CITY OF ALBUQUERQUE

**Re: Lot 2, McMahon Marketplace
Conceptual Grading and Drainage Plan
Engineer's Stamp Date (none), A11/D011A**

CONCEPTUAL GRADING AND DRAINAGE PLAN

SHEET NO:
CG-101

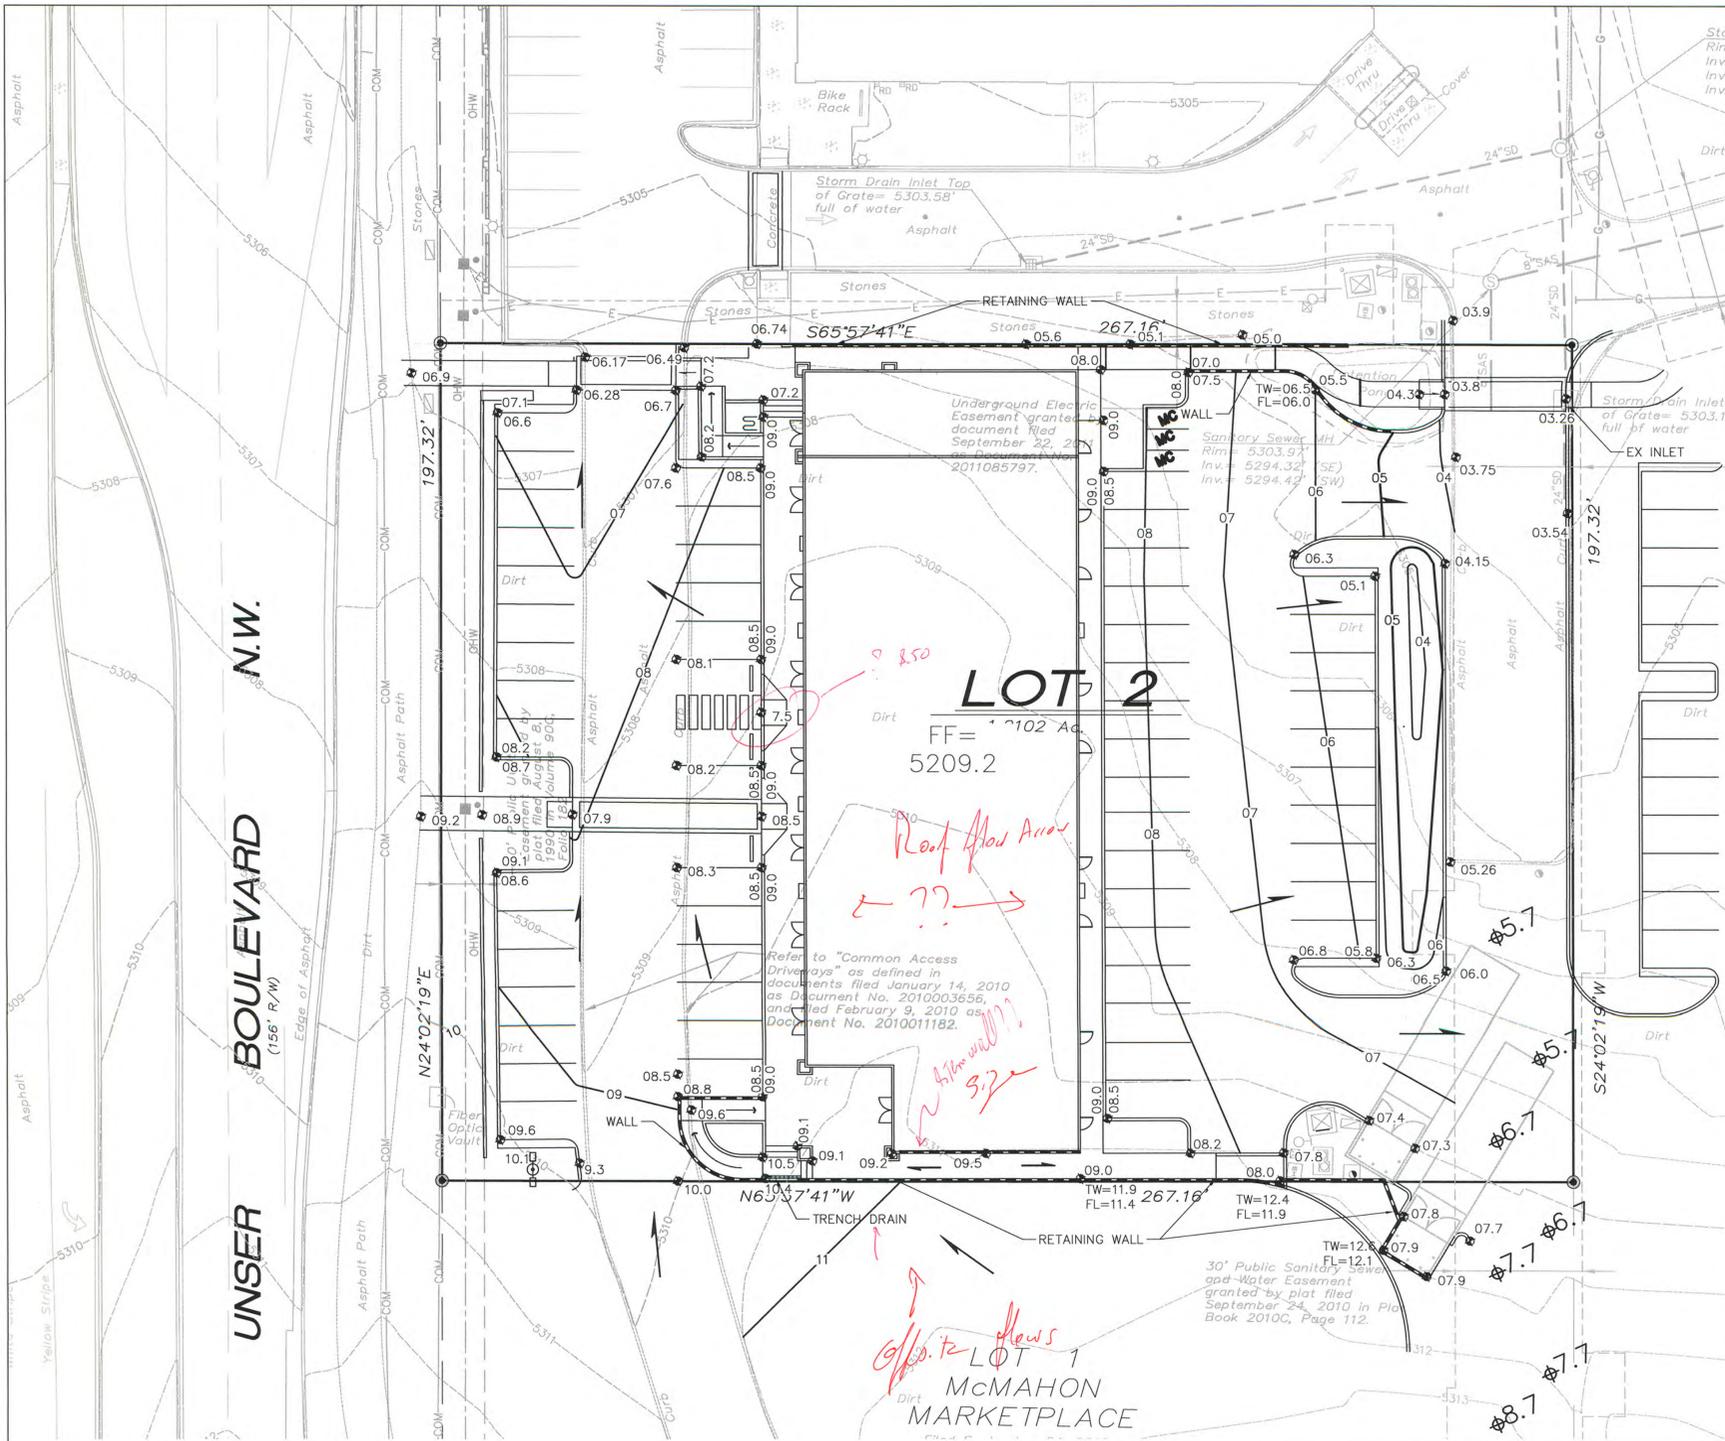
- This grading plan does not exactly follow the overall basin layout. Provide proposed basin layout based on the Lot 2 grading plan. Provide capacity calculations for the inlets which may be impacted by these changes.
- Include a City of Albuquerque BM on the plan (NAVD 88).
- Add Legends.
- Show roof flow directions.
- It appears that the spot elevation "7.50" by the ramps should be "8.50".
- How will the offsite runoff from the south drain through this site? Will there be a desilting pond?
- Provide additional top and bottom of wall elevations for the proposed retaining wall. Please call out the stem wall and size located on the south side of the building.
- If a restaurant is being proposed the trash enclosure area(s) must drain to the sewer system, and detail grades have to be added to the plan.
- Please make sure that the existing storm drain system is draining properly.
